Our Reference: 8027501

PA2017/5637 – Aspire Estate Stage 33 - Functional Layout Plan – Approval

ASPIRE ESTATE STAGE 33 FUNCTIONAL LAYOUT PLAN

MUNICIPALITY MELTON
 REFERENCE 8226 E/33

PASSIVE IRRIGATION INLET DETAIL
 SCALE - 1:20

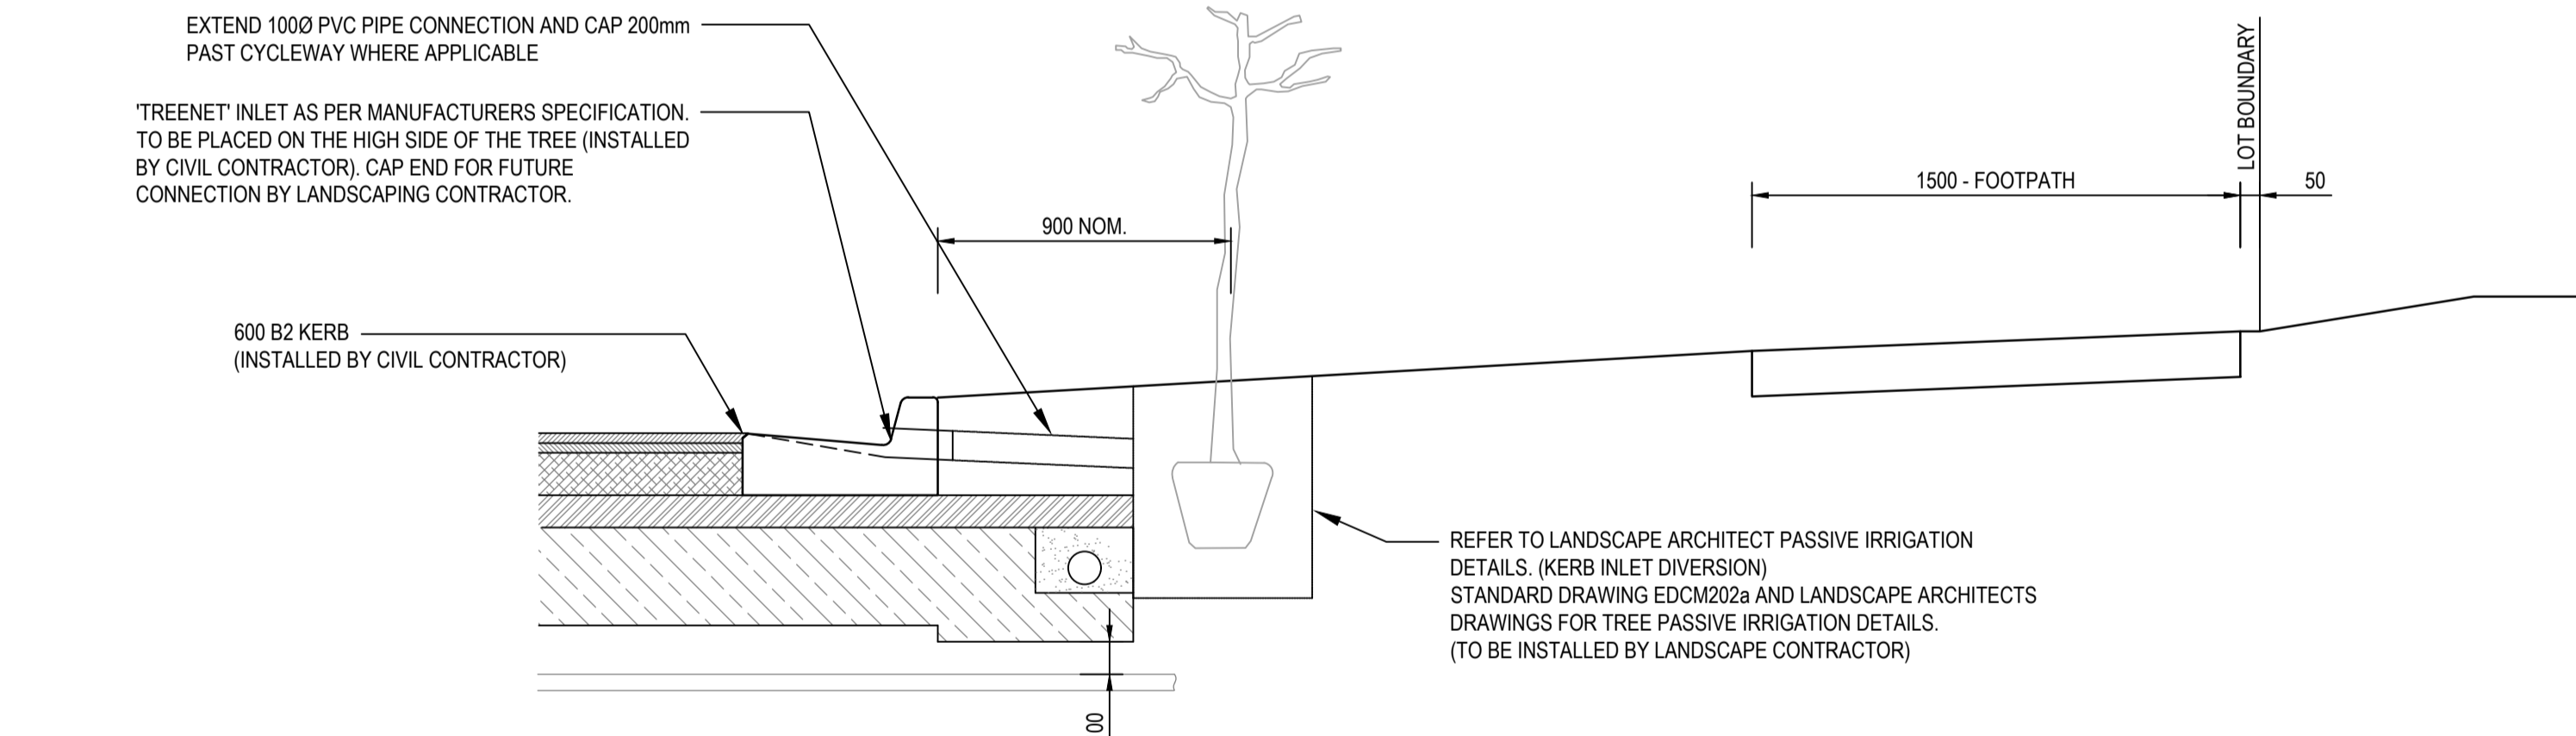
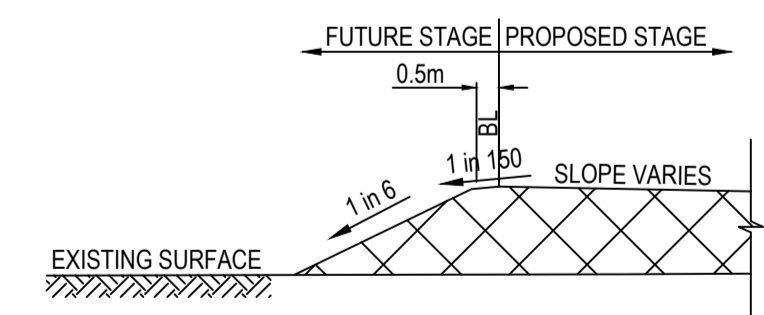
Details and locations of street tree passive irrigation must be shown on the detailed engineering plans consistent with the approved Integrated Water Management Plan and landscape plans. Clearly separate the components that will be constructed under the civil works and landscaping works. Council reserves the right to ask additional changes during the detailed engineering stage, to maximise the street tree passive irrigation deemed necessary.
